GROUP	MODEL
CHA	2024-2025MY Sorento (MQ4a)
NUMBER	DATE
127V	March 2025

TECHNICAL SERVICE BULLETIN

REAR SHOCK ABSORBER REPLACEMENT

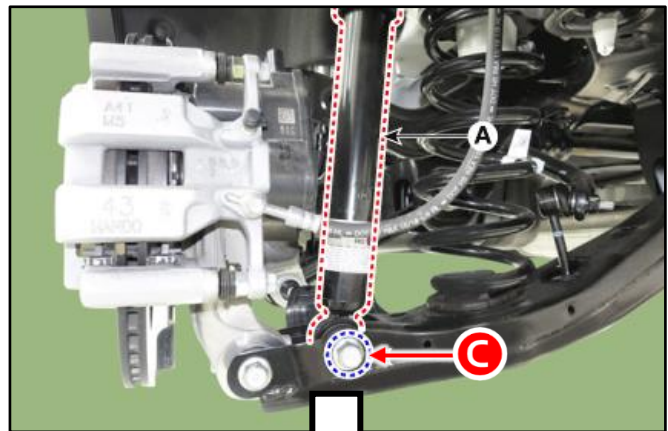
1. Replace both left and right rear shock absorber assemblies (A) by referring to "Suspension System → Rear Suspension System → Rear Shock Absorber → Repair procedures" in the applicable Shop Manual on KGIS.

Tightening torque for bolts (B):
86.8 - 101.3 lb.ft (117.7 - 137.3 N.m)

Tightening torque for bolt (C):
115.7 - 130.2 lb.ft (156.9 - 176.5 N.m)

Be sure to use the new self-locking nut PN 13262 10001 (one for each
